SCOTTISH HIGHLANDS SUBDIVISION

APPLICATION NUMBER 3 DATE December 21, 2017

DETAIL SITE PLAN

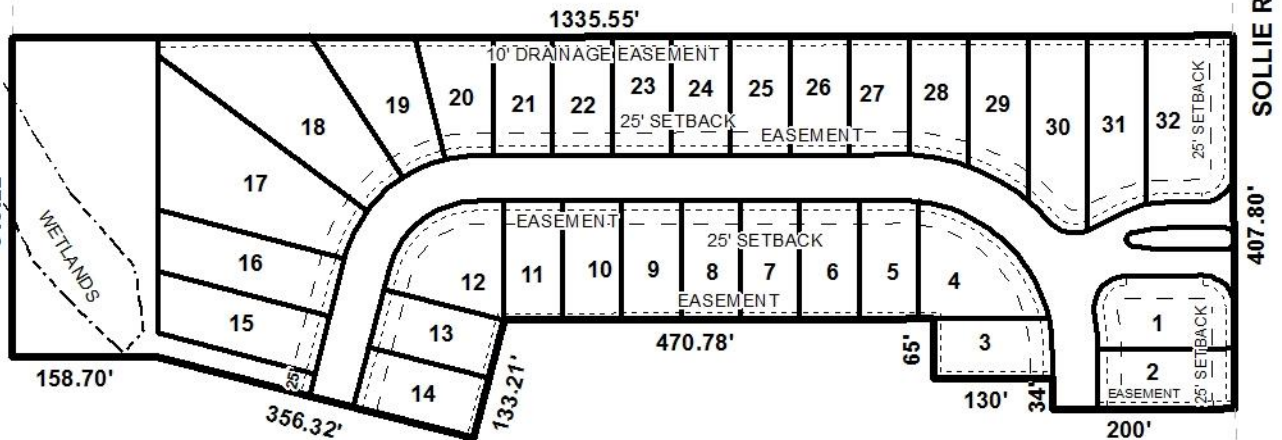
The proposed subdivision is accessed by Sollie Road, a planned major street with curb and gutter requiring 100' of right-of-way per the recently adopted Major Street Plan. The preliminary plat also illustrates the proposed construction of Scottish Highlands Drive, a minor street with curb and gutter requiring 50' of right-of-way. Lots 1, 2 and 32 each have frontage along both Sollie Road and Scottish Highlands Drive, whereas the remaining lots only have frontage along Scottish Highlands Drive. Right-of-way along Scottish Highlands Drive is depicted as being sufficient, thus no additional dedication should be required; however, the preliminary plat indicates the right-of-way along Sollie Road varies at this location and, as such, should be revised on the Final Plat to dedicate 50' from the centerline of Sollie Road, if approved.

It should be noted that Scottish Highlands Drive terminates as two street stubs in an area labeled "Future Development". Considering phased development is proposed, a preliminary layout of the future phases should be included as part of the application. As each phase develops, if approved, and if required by Mobile County Engineering, temporary turn-arounds in compliance with Sections V.B.6. and V.B.14 of the Subdivision Regulations regarding closed-end streets and turn-around rights-of-way, respectively, should be illustrated on the Final Plat at the terminuses of Scottish Highlands Drive. Also, the proposed street and its turn-around extensions must be built to Mobile County Engineering standards and be accepted by Mobile County prior to the signing of the Final Plat.

With regards to access management, a note on the preliminary plat states all lots are denied access to Sollie Road and limited to one (1) curb cut each to “streets within the subdivision.” If approved, the note should be revised on the Final Plat to deny access to Sollie Road and limit each lot to one (1) curb cut to Scottish Highlands Drive, with any changes in their sizes, locations, or designs to be approved by Mobile County Engineering and conform to AASHTO standards.

The area labeled “Future Development” consists of the remainder of the parcel from which the 32 lots and common area are proposed to be subdivided, but its dimensions are not labeled. If approved, the Final Plat should be revised to provide the size of the future development area in both square feet and acres; or, provision of a table on the Final Plat providing the same information may suffice. And, as previously mentioned, a preliminary layout of future phases should also be provided.

Per Section V.D.9. of the Subdivision Regulations, the 25’ minimum building setback line is illustrated along all street frontages to which the proposed lots abut, but is not illustrated along Sollie Road where the future development area has frontage. As such, revision of the plat to illustrate the 25’ minimum building setback line along all street frontages should be required, if approved, adjusted for any required dedication(s).

Multiple easements are illustrated on the plat, including: a 10’ fence and landscape easement along Sollie Road; a 7.5’ drainage easement at the rear property lines of Lots 2-14; a 10’ drainage easement at the rear property lines of Lots 18-32; and two (2) 45’ radius temporary turn-around easements at the front property lines of Lots 13, 14, and 15, and along Scottish Highlands Drive where the proposed common area can be accessed. A note iterating no structures shall be built in any easement is provided on the preliminary plat and should be retained on the Final Plat, if approved.

This application is recommended for Holdover to the December 21st meeting, with materials submitted by December 15th, to allow the applicant to do the following:

- 1) Revise the preliminary plat to show a preliminary layout of the proposed phasing of the future development area.

Staff has not received any revised information from the applicant; therefore, it is recommended the application be withdrawn until such time the applicant can submit a new application with the requested information.
